Dip Knitwear Ltd.

15 May 2014

Main Factory Building - Typical Floor Plan

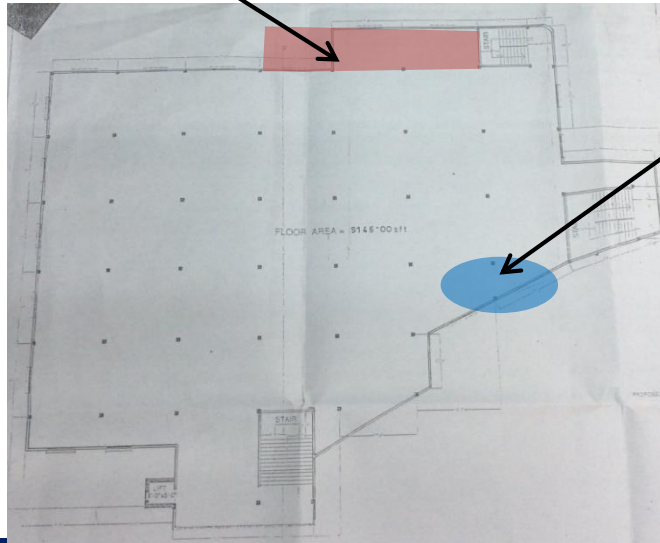
**Column Indicated on Structural Drawings
Not Provided Introducing a 3.0m Cantilever**

Column indicated on structural drawings not provided introducing a 3.0m Cantilever.

Cursory Calculations indicate cantilever beams to be stressed in excess of design limits

Toilet Build-up and Brick Partitions on Cantilever

Item No.	Observation	Recommended Action Plan	Recommended Timeline
1	Column Indicated on Structural Drawings Not Provided Introducing a 3.0m Cantilever	A Detail Engineering Assessment (D.E.A.) of Factory to be commenced, see attached Scope	Immediate - Now
2	Column Indicated on Structural Drawings Not Provided Introducing a 3.0m Cantilever	Factory Engineer to review design, loads and cantilever stresses in area identified above.	Immediate - Now
3	Column Indicated on Structural Drawings Not Provided Introducing a 3.0m Cantilever	Verify insitu concrete strength either by 100mm diameter cores or existing cylinder strength data for cantilever identified above.	Immediate - Now
4	Column Indicated on Structural Drawings Not Provided Introducing a 3.0m Cantilever	All loading in excess of 1kN/m ² on cantilever to be removed immediately.	Immediate - Now
5	Column Indicated on Structural Drawings Not Provided Introducing a 3.0m Cantilever	Detail Engineering Assessment to be completed	6-weeks

Main Factory Building - Typical Floor Plan

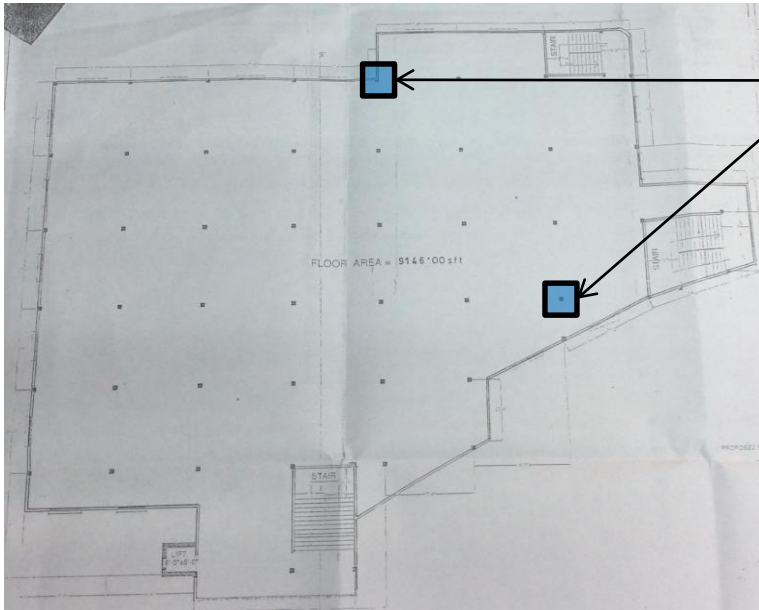
Cursory Calculations indicate columns to be stressed in excess of design loads for the proposed 5 Storey Building

Testing Conformed Brick Aggregate in ground floor columns. Cursory calculations indicate column stress is in excess of design limits.

Item No.	Observation	Recommended Action Plan	Recommended Timeline
12	Cursory Calculations indicate column stresses in excess of normal design limits	A Detail Engineering Assessment (D.E.A.) of Factory to be commenced, see attached Scope	Immediate - Now
13	Cursory Calculations indicate column stresses in excess of normal design limits	Factory Engineer to review design, loads and columns stresses in area identified above.	Immediate - Now
14	Cursory Calculations indicate column stresses in excess of normal design limits	Verify insitu concrete stresses either by 100mm diameter cores or existing cylinder strength data for cores from 4 columns.	Immediate - Now
15	Cursory Calculations indicate column stresses in excess of normal design limits	Detailed Engineering Assessment to be completed	6-weeks
16	Cursory Calculations indicate column stresses in excess of normal design limits	Produce and actively manage a loading plan for all floor plates within the factory giving consideration to floor capacity and column capacity. This should include a safe level to which any water tanks can be filled.	6-weeks

Main Factory Building – 1st Floor Plan

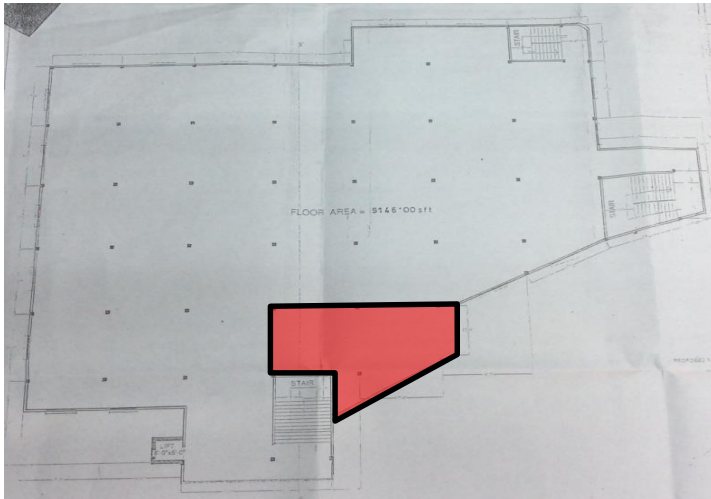
Localised areas of high loading

High loading area on 1st floor

Item No.	Observation	Recommended Action Plan	Recommended Timeline
18	Localised areas of high loading	Produce and actively manage a loading plan for all floor plates within the factory giving consideration to floor capacity and column capacity. This should include a safe level to which any water tanks can be filled.	6-weeks
19	Localised areas of high loading	Continue to implement load management plan	6-months
20	Inconsistencies noted between drawings and as built construction	Building Engineer to survey as constructed building and update drawings as required.	6-weeks

Main Factory Building – 3rd Floor Plan

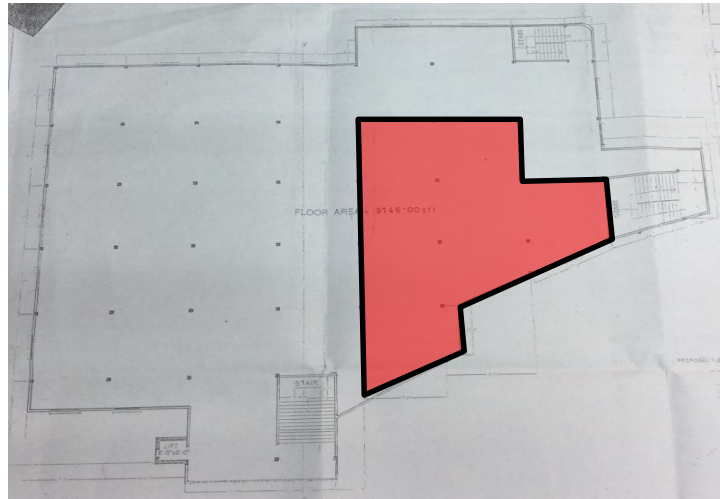
High loading area on 3rd floor

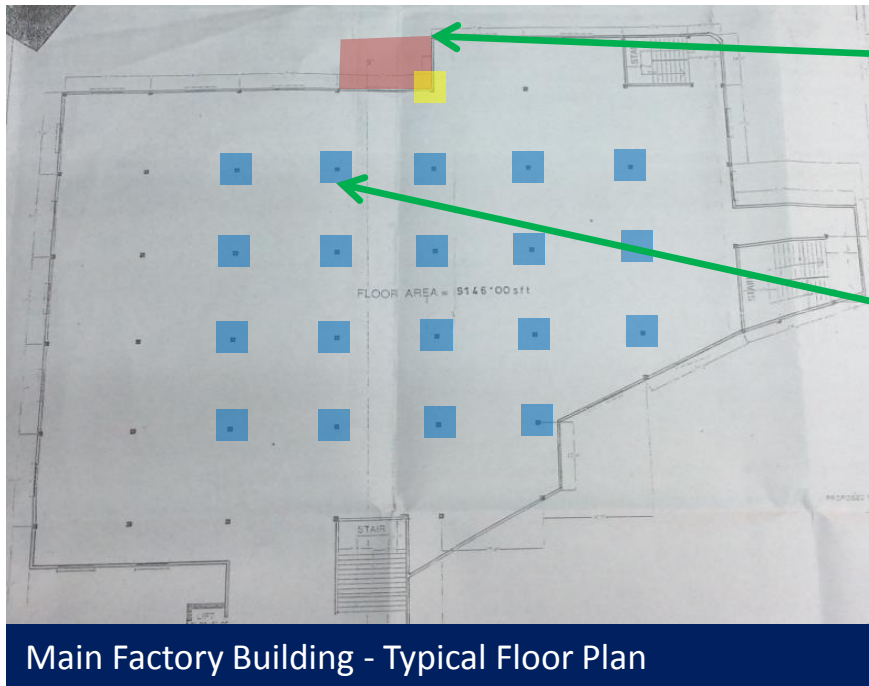
Inconsistencies noted between drawing & as built construction

Increased floor area on every floor

Column size on the drawing 500mm x 500mm
Observed column size 3rd and 4th floor - 510mm x 515mm (Without Plaster)
Ground to 2nd floor – 450mm x 450mm (Without Plaster)

Drawing column size 400mm x 400mm. As built column at ground floor 510mm x 515mm
